Regional Review Finding Development of Regional Impact

RE: Development of Regional Impact (DRI) Review

Name of Proposal: T5 ATL IV DRI 4465

Description: *A DRI review of a proposal to construct six data center buildings totaling 2,184,000 square feet of space along with associated infrastructure, access, parking, utilities, and stormwater management and a new power substation on a 119-acre mostly wooded site off of Gullatt Road primarily in the city of Fairburn with a smaller portion of the property in the City of Palmetto in Fulton County.*

GSWCC NO. (LEVEL II) 0000008170
DRAWN BY EJD
DESIGNED BY MMM
REVIEWED BY DBA
DATE 06.27.2025
PROJECT NO. 013440009
TITLE **SITE PLAN**
SHEET NUMBER **C2.00**

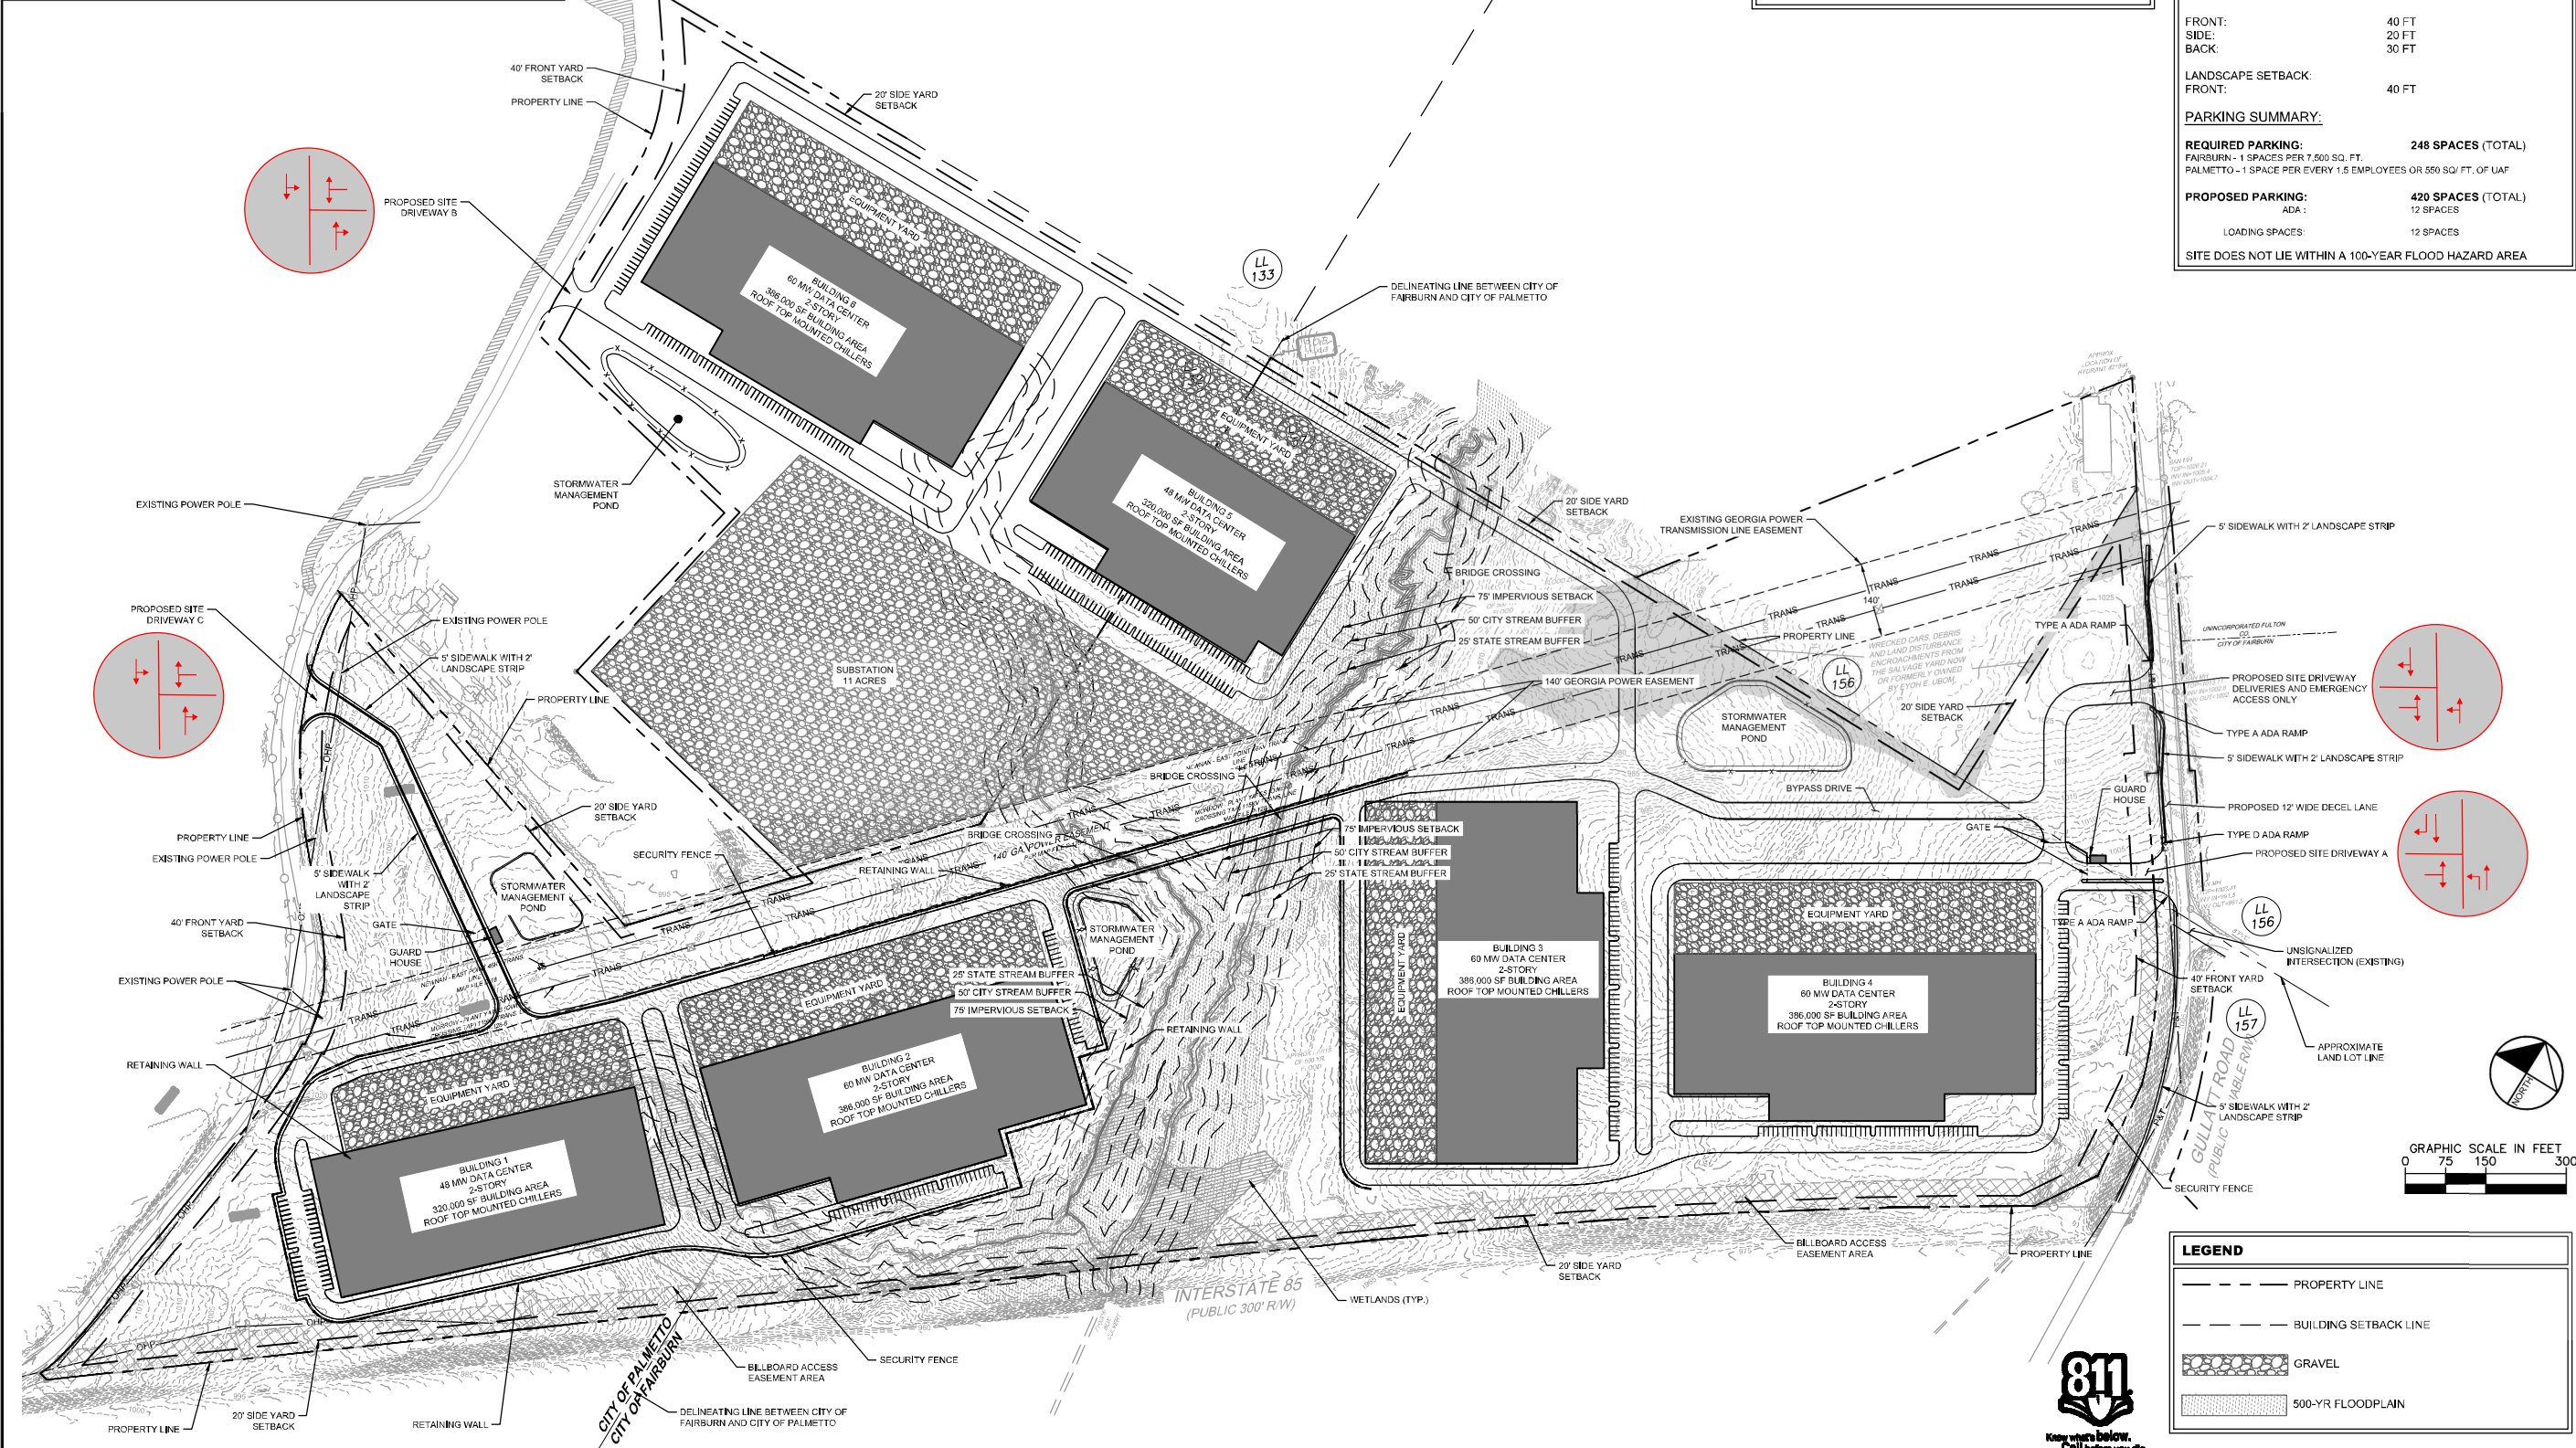
As mentioned in the previous section, both the USGS coverage for the project area and the proposed project site plan show a blue-line stream, Shoal Creek, running north to south through the center of the property. The site plan also shows two tributaries flowing into Shoal Creek on the project property. The submitted site plan shows no development in the State 25-foot Sediment and Erosion Control buffer along Shoal Creek, but as mentioned above, two intrusions in the City's 50-foot undisturbed buffer and 75-foot impervious surface setback along Shoal Creek are shown on the site plan. Again, these intrusions are an access drive along Building 5 and portions of the parking area and the corner of building at Building 2. Intrusions into both the State and City buffers are also visible along the two unnamed tributaries to Shoal Creek. The intrusions are portions of Buildings 1, 2 and 8, as well as parking, equipment yards and the proposed substation. They are either intruding into the buffers or entirely covering them. In addition to the possible Part 5 Criteria issues discussed in the previous section, these intrusions will require variances to these buffer requirements.

The FEMA FIRM coverage for the project area shows a 500-year floodplain along Shoal Creek, but no 100-year floodplain or floodway are indicated. The 500-year floodplain is shown on the submitted site plan and is identified in the legend. A portion of Building 5 and an adjacent driveway appear to intrude into the indicated floodplain on the plans. While there appear to be no specific City requirements for development in the 500-year floodplain, portions of the project in the floodplain should be designed to protect against possible future flooding.

This permit requires FCWS to perform special conditions monitoring on Shoal Creek, specifically inflow. If inflow is reduced significantly FCWS must adjust its operational habits. The site plan shows tributaries to Shoal Creek are not being protected, and impervious area is being constructed over the tributaries. Although stormwater may be retained it may not be allowed back into the Shoal Creek Watershed and this impervious area could constrain the amount of flow into Shoal Creek. Fayette County is requesting buffers be placed on these tributaries. EPD mandated Fayette County adopt and enforce a Watershed Protection Ordinance placing buffers on Lake McIntosh as it is categorized as a small watershed water supply reservoir. These buffers are much greater than the minimum standard called out on the site plan. Fayette County requests that the buffers equal to Line Creek buffers required by the FC Watershed Protection Ordinance be adhered to. These are 100 ft. Undisturbed buffers with an additional 50 ft. Impervious setback.

This permit requires FCWS to perform special conditions monitoring on Shoal Creek, specifically inflow. If inflow is reduced significantly FCWS must adjust its operational habits. The site plan shows tributaries to Shoal Creek are not being protected, and impervious area is being constructed over the tributaries. Although stormwater may be retained it may not be allowed back into the Shoal Creek Watershed and this impervious area could constrain the amount of flow into Shoal Creek. Fayette County is requesting buffers be placed on these tributaries.

EPD mandated Fayette County adopt and enforce a Watershed Protection Ordinance placing buffers on Lake McIntosh as it is categorized as a small watershed water supply reservoir. These buffers are much greater than the minimum standard called out on the site plan. Fayette County requests that the buffers equal to Line Creek buffers required by the FC

Watershed Protection Ordinance be adhered to. These are 100 ft. Undisturbed buffers with an additional 50 ft. Impervious setback.

As mentioned in the previous section, both the USGS coverage for the project area and the proposed project site plan show a blue-line stream, Shoal Creek, running north to south through the center of the property. The site plan also shows two tributaries flowing into Shoal Creek on the project property. The submitted site plan shows no development in the State 25-foot Sediment and Erosion Control buffer along Shoal Creek, but as mentioned above, two intrusions in the City's 50-foot undisturbed buffer and 75-foot impervious surface setback along Shoal Creek are shown on the site plan. Again, these intrusions are an access drive along Building 5 and portions of the parking area and the corner of building at Building 2. Intrusions into both the State and City buffers are also visible along the two unnamed tributaries to Shoal Creek. The intrusions are portions of Buildings 1, 2 and 8, as well as parking, equipment yards and the proposed substation. They are either intruding into the buffers or entirely covering them. In addition to the possible Part 5 Criteria issues discussed in the previous section, these intrusions will require variances to these buffer requirements.

The FEMA FIRM coverage for the project area shows a 500-year floodplain along Shoal Creek, but no 100-year floodplain or floodway are indicated. The 500-year floodplain is shown on the submitted site plan and is identified in the legend. A portion of Building 5 and an adjacent driveway appear to intrude into the indicated floodplain on the plans. While there appear to be no specific City requirements for development in the 500-year floodplain, portions of the project in the floodplain should be designed to protect against possible future flooding.

No. There are limited sidewalks and no bike lanes within the development. There are also no crosswalks. Marked crossings should be at main entrances of development along with sidewalks from main roads into the development.
